TECHNICAL MODIFICATIONS FOR THE FLOWER MARKET PROJECT; CF 19-1048 / 19-1048-S1

CF 19-1048, CASE NO. VTT-74568-1A

Revised Exhibit A

VESTING TENTATIVE TRACT MAP FOR MERGER AND SUBDIVISION PURPOSES FOR:
TENTATIVE TRACT NO. 74568
SOUTHERN CALIFORNIA FLOWER GROWERS INC
709-765 S. WALL STREET
IN THE CITY OF LOS ANGELES COUNTY OF LOS ANGELES STATE OF CALIFORNIA

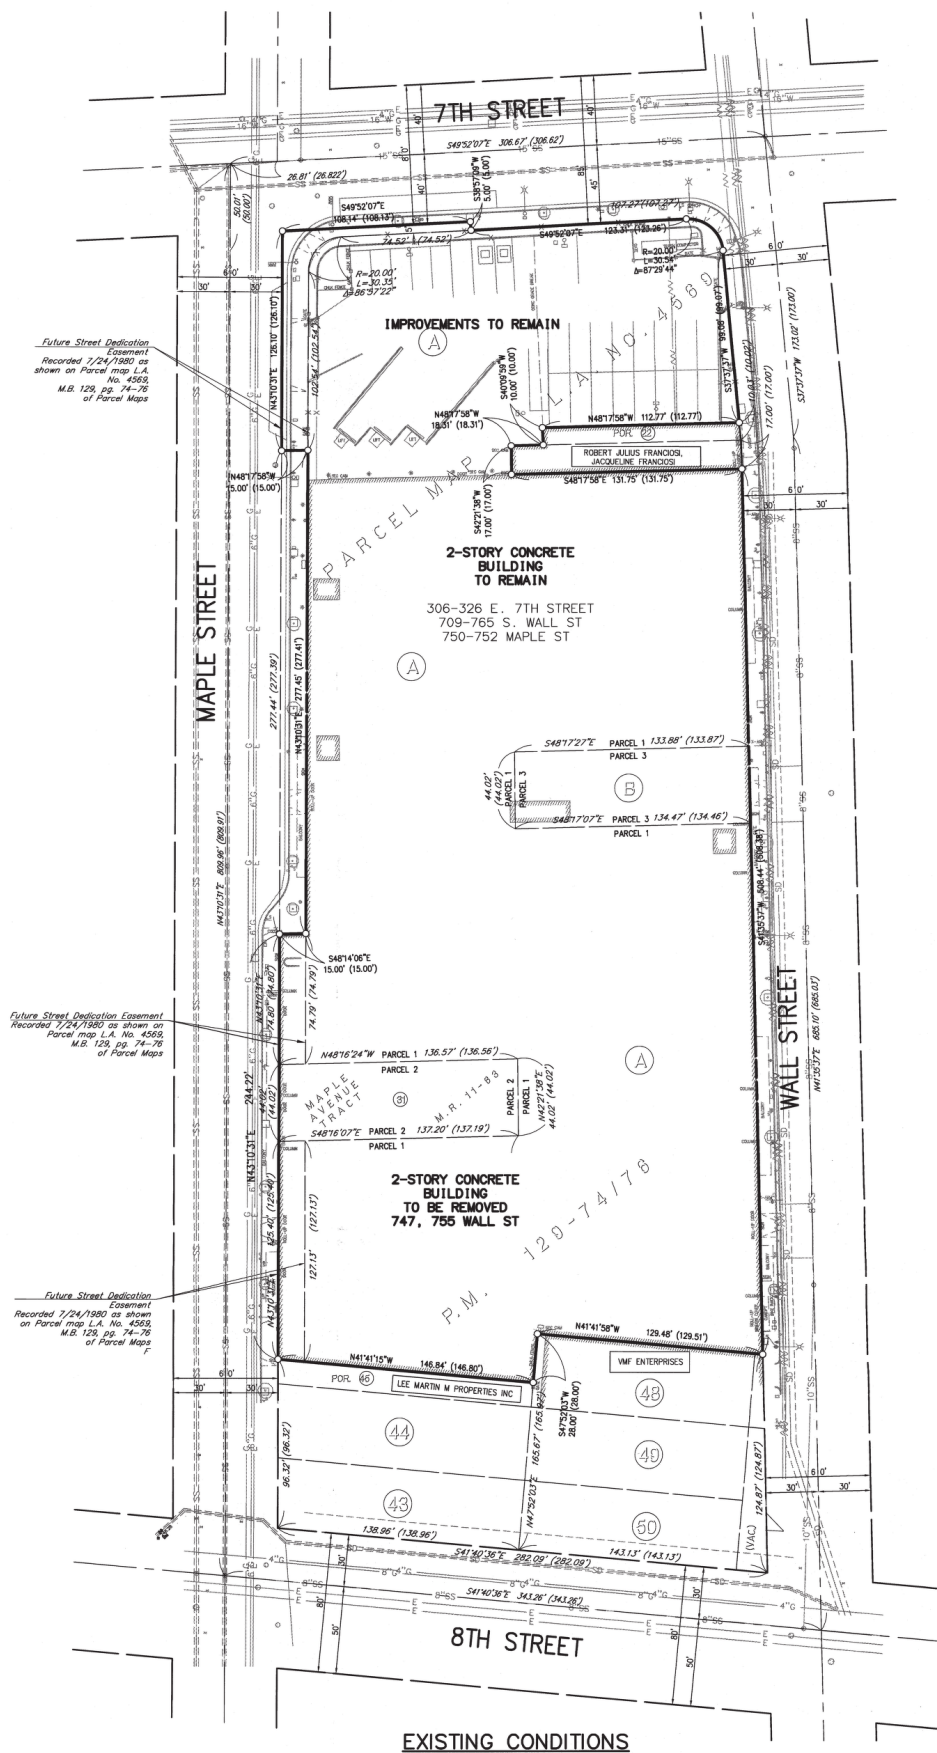
The Letter of Determination (LOD) for VTT-74568, dated June 3, 2019, referenced a Vesting Tentative Tract (VTT) map stamped-approved July 11, 2018. However, a map stamp-dated October 15, 2016 was inadvertently attached to the LOD as the approved Exhibit A, and carried forward as part of the Exhibit C in the Appeal Report to the CPC dated August 8, 2019. The correct map is actually dated February 9, 2018, and was inadvertently referenced with the July date due to a separate stamp on the map from the Department of Building & Safety Grading Division dated July 11, 2018.

Staff recommends that that any reference in the Vesting Tract Map LOD and Conditions of Approval to the July 11, 2018 date be replaced with the February 9, 2018 date; and that the VTT map dated February 9 2018, attached an Enclosure to this letter, replace the existing Exhibit A wherever referenced.
